**MONTGOMERY COUNTY HISTORIC PRESERVATION COMMISSION**  
**STAFF REPORT**

<b>Address:</b>	29 West Irving Street, Chevy Chase	<b>Meeting Date:</b>	10/27/2021
<b>Resource:</b>	Contributing Resource (Chevy Chase Village Historic District)	<b>Report Date:</b>	10/20/2021
<b>Applicant:</b>	Allison and Peter McDonnell (Case Design & Remodeling, Agent)	<b>Public Notice:</b>	10/13/2021
<b>Review:</b>	HAWP	<b>Tax Credit:</b>	No
<b>Permit Number:</b>	953229 REVISION	<b>Staff:</b>	Michael Kyne
<b>PROPOSAL:</b> Fenestration alterations and alterations to the rear elevation

Proposed Left Side Exterior Elevation/ Option A  
Scale: 1/4" = 1'-0"

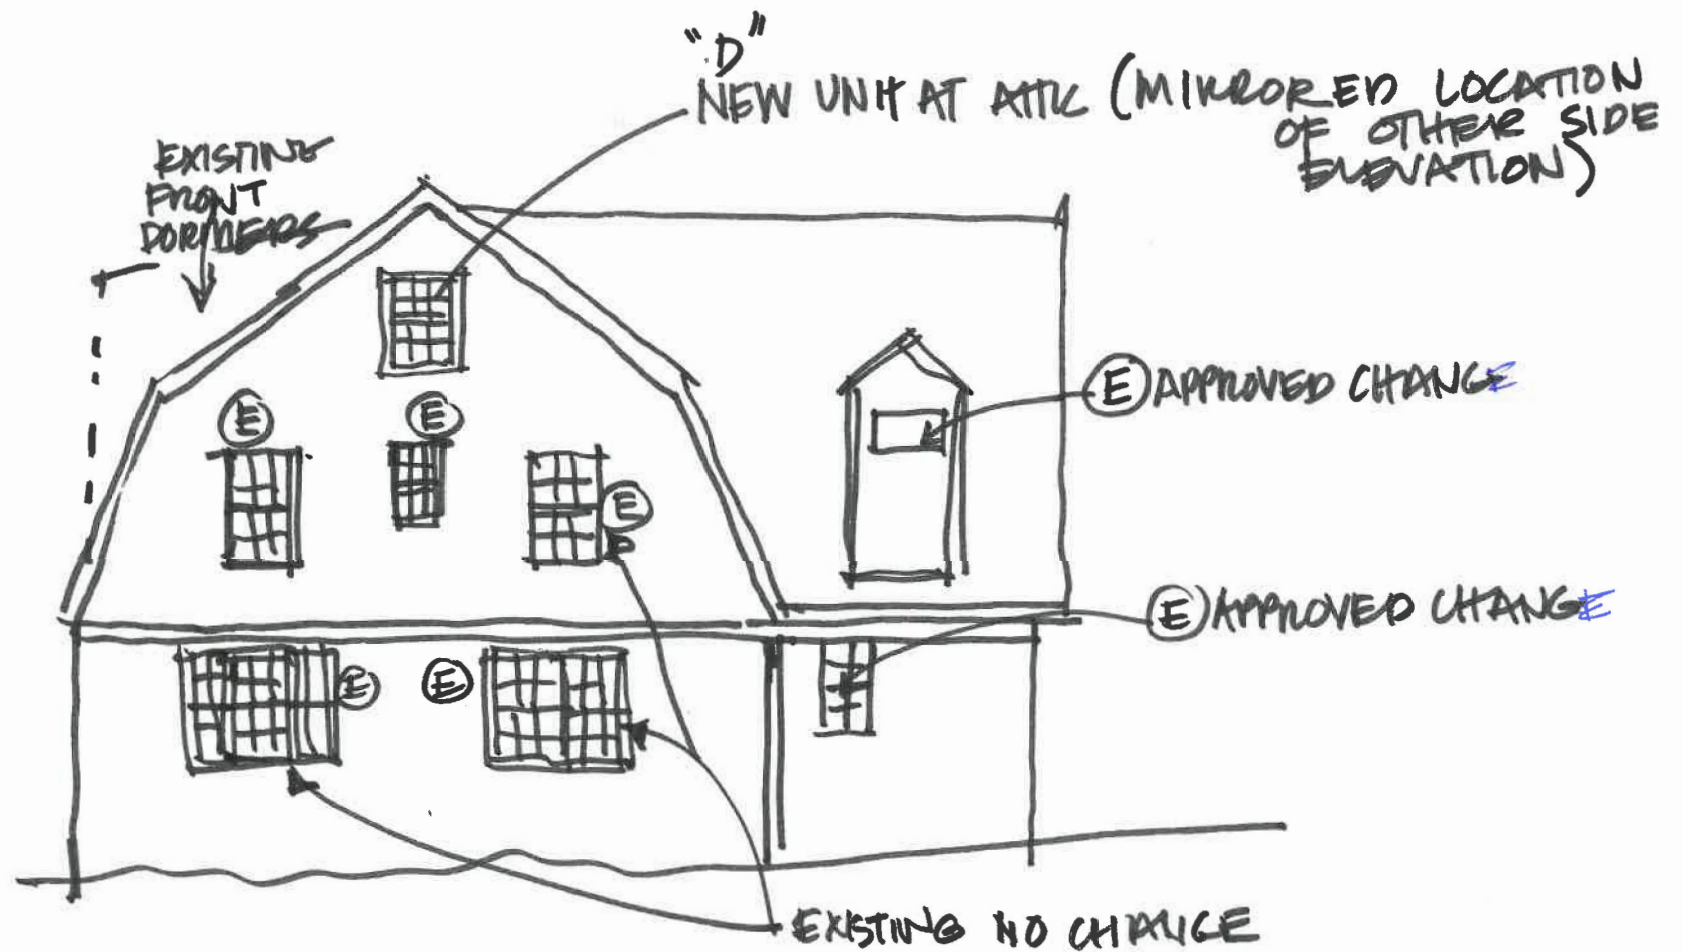
- The previously approved new 6-over-6 aluminum-clad double-hung window on the second floor, west/left elevation of the historic house has been removed from the proposal.
- Removal of the half-round windows in the gables of the historic house (one on the west/left

- elevation, and one on the east/right elevation).
- Installation of new 6-over-6 aluminum-clad double-hung windows in the gables of the historic house (one on the west/left elevation, and one on the east/right elevation) for egress purposes.
  - As with the previous approval, the proposed windows will have permanently-affixed 7/8" interior and exterior muntins with internal spacer bars, and the new window casings will be constructed from wood to match the existing.
  - The proposed windows will match the style of the existing and previously approved window, but it will be reduced in height to be no more than 48" high.

Staff supports the applicants' proposal, finding it consistent with the *Guidelines*. As with the previously approved new window on the second floor, west/left elevation of the historic house, staff finds that the proposed fenestration alterations will be visible from oblique angles within the public right-of-way of West Irving Street. Accordingly, staff finds that the proposal should be subject to moderate scrutiny. Per the *Guidelines*, moderate scrutiny "involves a higher standard of review than 'lenient scrutiny.'" Besides issues of massing, scale and compatibility, preserving the integrity of the resource is taken into account. Alterations should be designed so that the altered structure still contributes to the district. Use of compatible new materials, rather than the original building materials, should be permitted. Planned changes should be compatible with the structure's existing design, but should not be required to replicate its architectural style."

Staff finds that the proposed fenestration alterations will preserve the integrity of the resource and the house will still contribute to the district. As noted, the use of compatible new materials, as proposed, should be permitted. Because the proposed new windows will match the style of the existing 6-over-6 historic windows, staff finds them to be compatible with the structure's existing design.

Staff recommends that the Commission **approve** the HAWP application under the Criteria for Issuance in Chapter 24A-8(b) (1), (2), and (d), having found that the proposal is consistent with the *Chevy Chase Village Historic District Guidelines* identified above, and therefore will not substantially alter the exterior features of the historic resource and is compatible in character with the district and the purposes of Chapter 24A;
